1:50 PROPOSED "SIDE" ELEVATION FROM N. 45.4

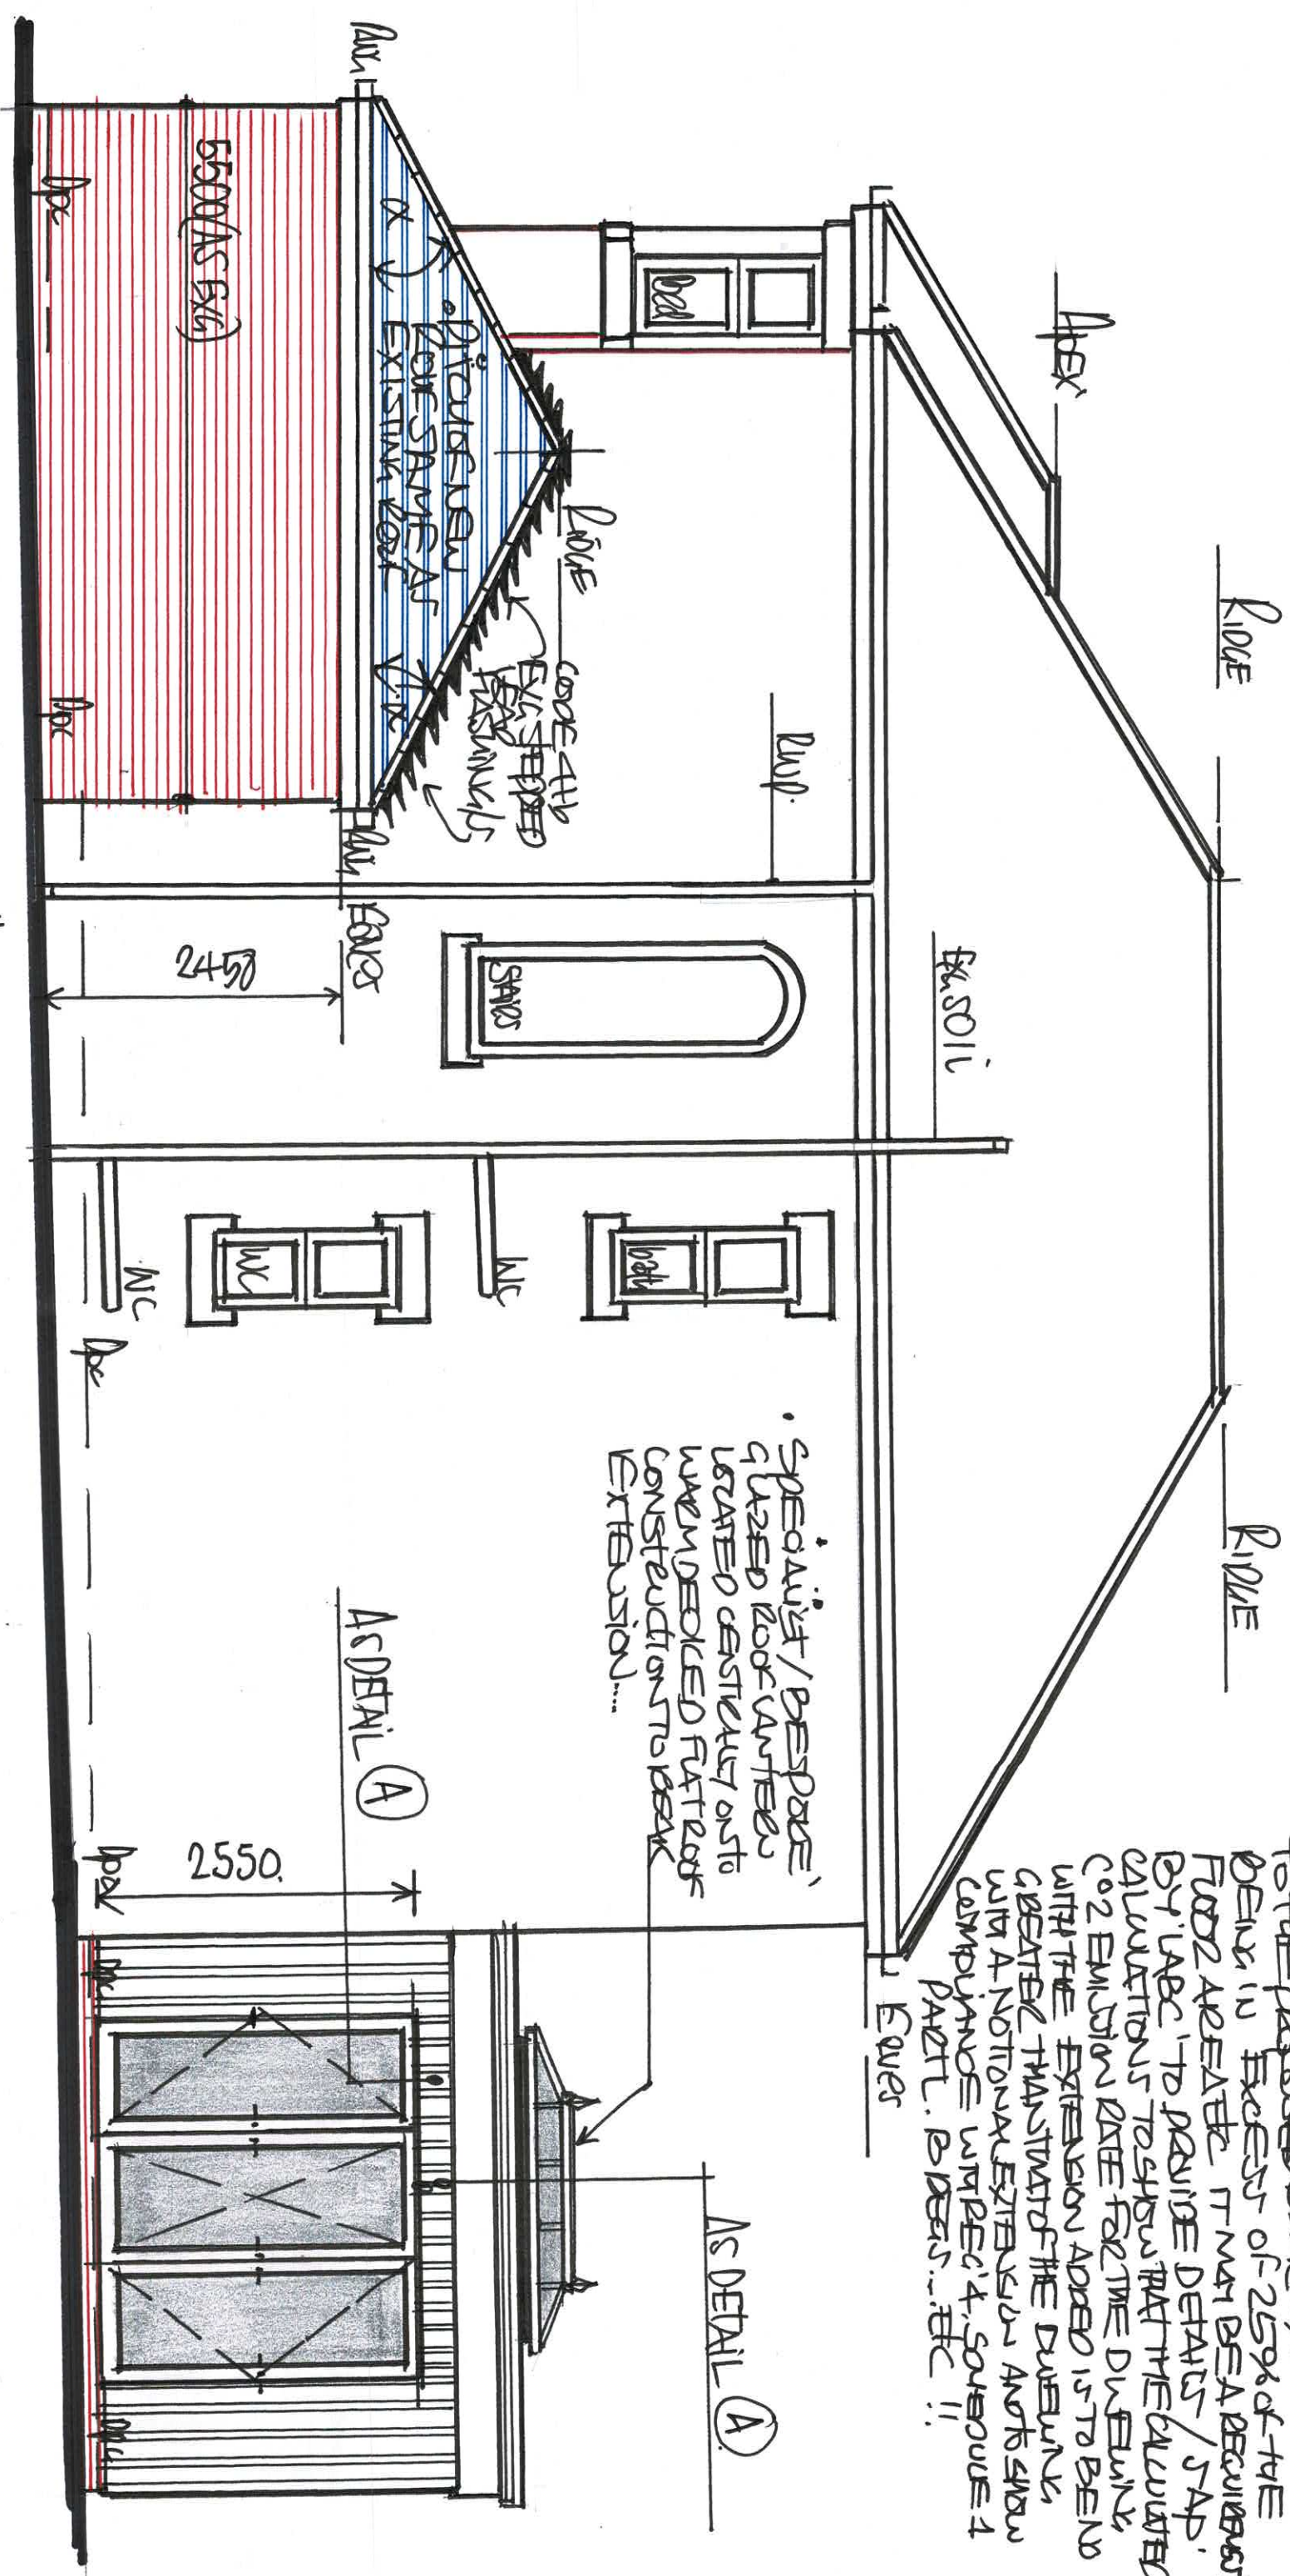
DUE TO EXCESSIVE AMOUNT OF CURVING TO THE PROPOSED BEAR EXTENSION TO THE EXISTING OF 25% OF THE BEAR IN EXCESS OF 25% OF THE PROPOSED BEAR EXTENSION BY LABC TO PROVIDE DETAILS / SAP. CALCULATIONS TO SHOW THAT THE CALCULATED CO2 EMISSION RATE FOR THE DWELING WITH THE EXTENSION ADDED IS TO BE NO GREATER THAN THAT OF THE DWELING WITH A NOTIONAL EXTENSION AND TO SHOW COMPLIANCE WITH REG 4, SOURCE 1 PART 1, B. DEBS... ETC !!
